MONITORING YEAR 2 ANNUAL REPORT Final

OWL'S DEN MITIGATION SITE

Lincoln County, NC
DEQ Contract 005150
DMS Project Number 95808

RE: Owl's Den Mitigation Site-Year 2 Monitoring Report
Final Submittal for DMS
Contract Number 004673, RFP Number 16-004110, DMS# 95360
Yadkin River Basin – CU# 03040105; Union County, NC

Table 5a. Visual Stream Morphology Stability Assessment Table

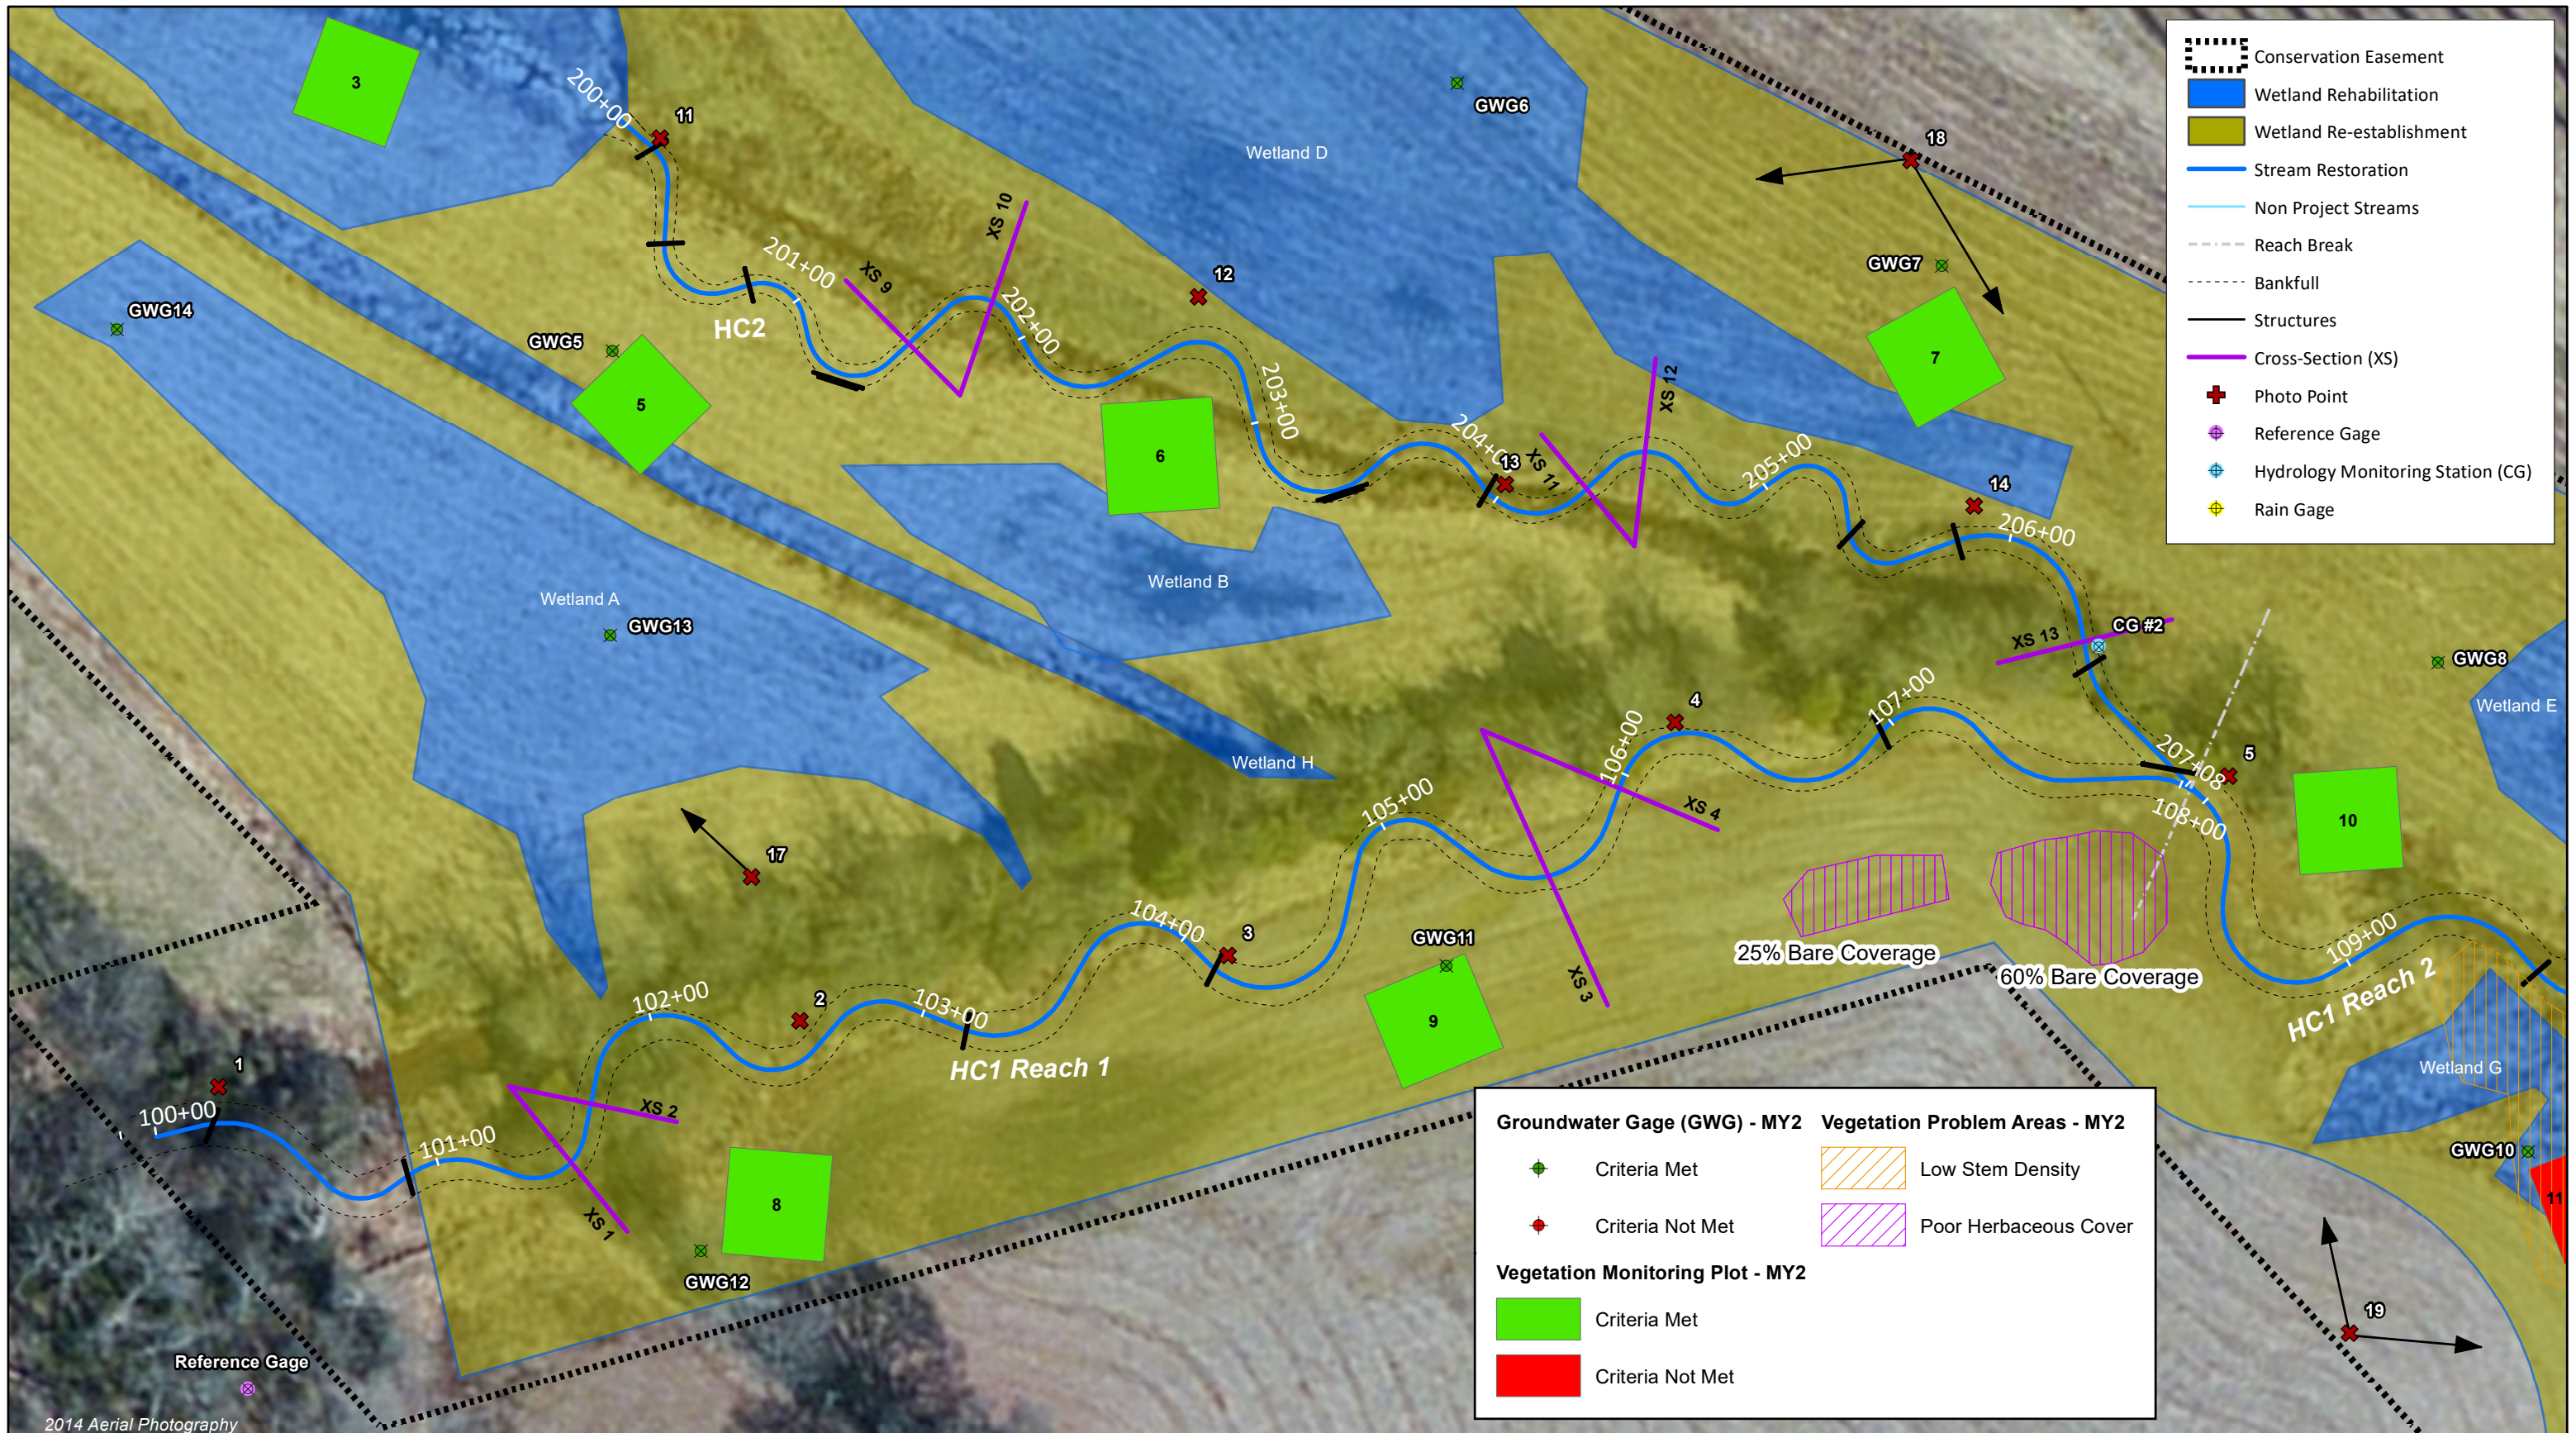
This section reports an area near VP3 with low planted woody stem density. The CCPV mapping does not show any low stem density areas near VP3. The low stem density areas are shown near VP 11. Please update the report and/or CCPV maps accordingly.

Wildlands Response; The report verbiage in Section 1.2.5 has been updated to note the area near VP11 has low planted woody stem density rather than VP3. No changes were made to the CCPV map.

Recorded In-stream Flow Events

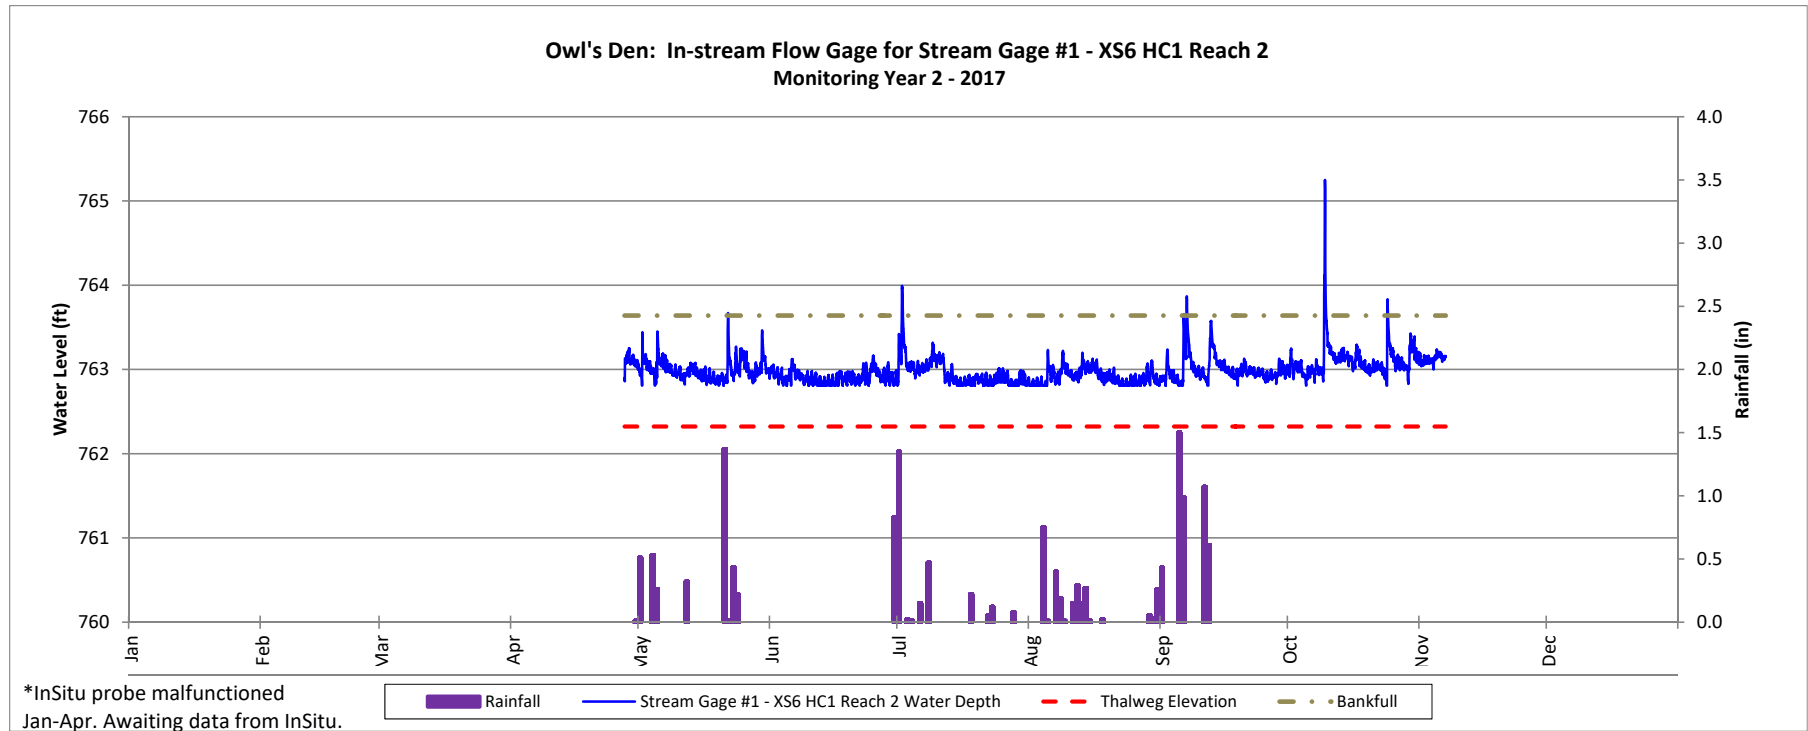
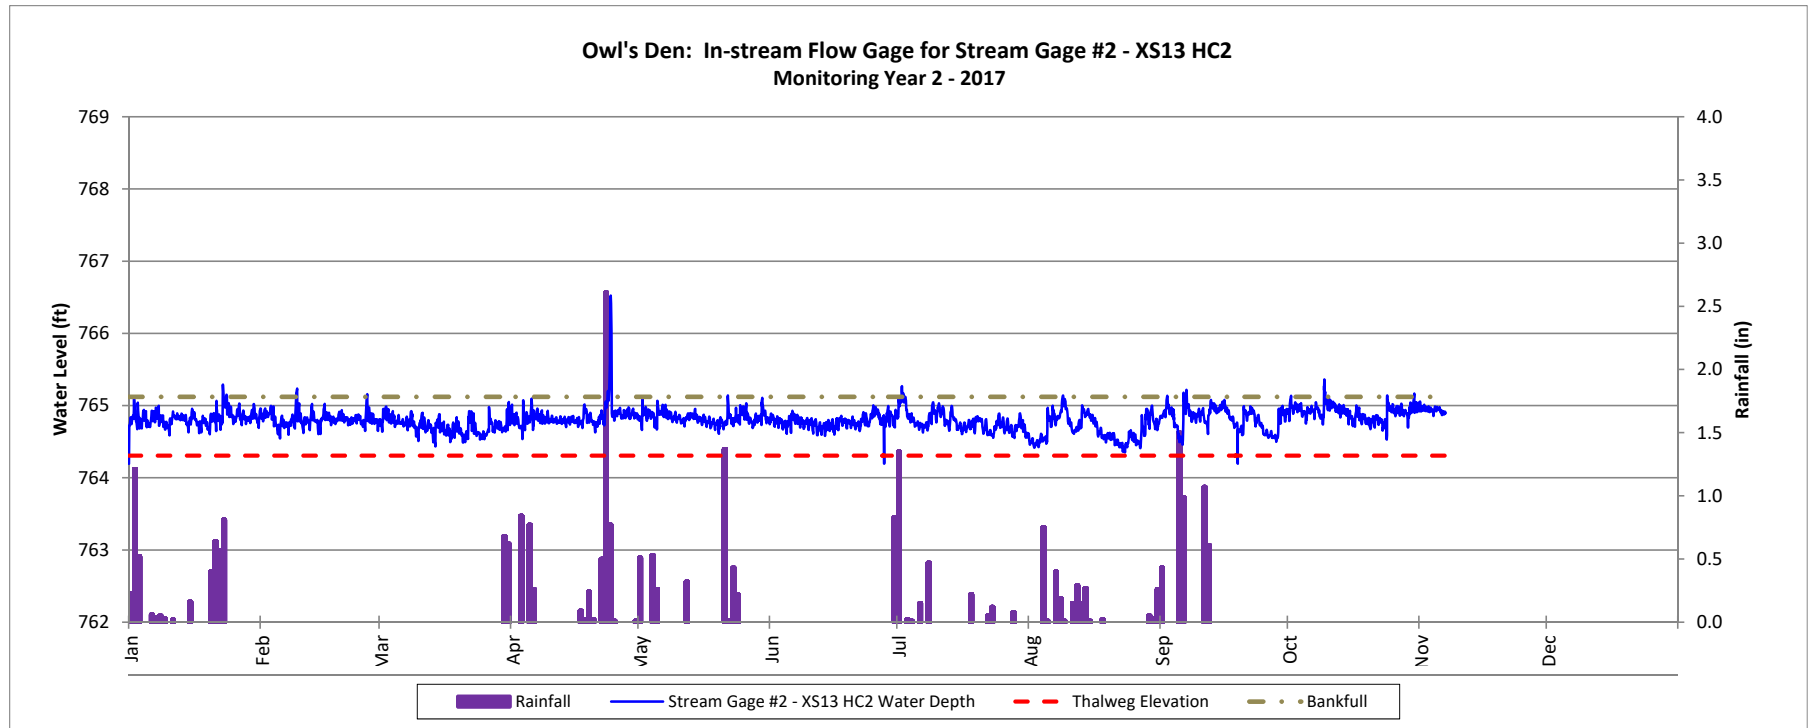
DMS Comment; Table 13 – The table reports ten (10) bankfull events on HC2 and five (5) bankfull events on HC1 for MY2/ 2017. A significant number of bankfull events were also reported in MY1. It is not typical for a site to have that many bankfull events in a given monitoring year. Please confirm the # of bankfull events reported on HC1 & HC2 and provide an explanation for the atypical number of bankfull events reported.

Wildlands Response; Wildlands reviewed the bankfull data for MY1 and MY2 and confirm the reported bankfull events are accurate.

The stream design discharge on this site was purposely selected to allow more frequent overbank flooding to restore wetland hydrology. The site is functioning as intended. Wildlands has not seen negative effects from the frequent bankfull events. The stream channels were restored as low gradient, wide shallow channels to help reestablish hydrology to the potential wetland areas and restore the natural flooding regime of the system. The design intended to raise channel beds to reduce drawdown effects of the channels and raise the water table in these areas thus restoring a balanced wetland and stream complex
